WBN-TS-01-04

**WATTS BAR NUCLEAR PLANT (WBN) - TECHNICAL SPECIFICATION CHANGE
TS-01-04, DIESEL GENERATOR (DG) RISK INFORMED ALLOWED OUTAGE TIME
(AOT) EXTENSION - REQUEST FOR ADDITIONAL INFORMATION AND
SUPPLEMENT TO AMENDMENT REQUEST**

Enclosure 1
NRC Request for Additional Information
From the Review of TVA's Letter Dated August 7, 2001
Technical Specification Change TS-01-04
Diesel Generator (DG) Risk Informed Allowed Outage Time (AOT) Extension

Enclosure 2
Response to NRC's November 28, 2001,
Request for Additional Information and
Supplemental Response to TVA's Letter Dated August 7, 2001

**Spectrum of Application Effectively
Supported by the PSA**

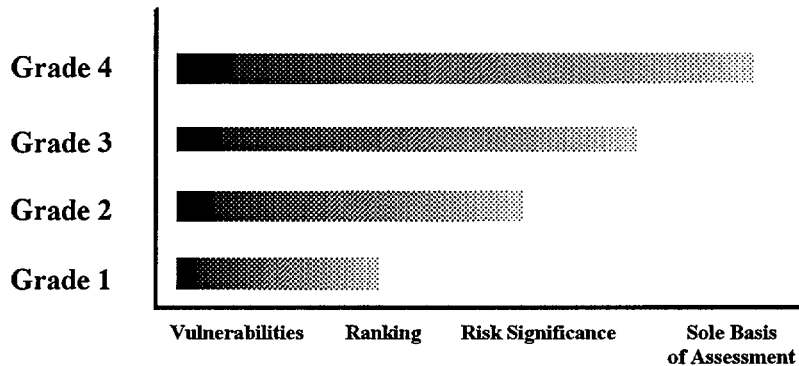
It should be noted that each of the PSA elements listed above were graded by the review team using the following scale. The assigned grades are reflected in the above table and indicate that the WBN PSA is basically adequate for risk informed applications once the specific review observations are addressed. The information provided in this enclosure discusses the relevant observations and TVA's initial disposition of the observations:
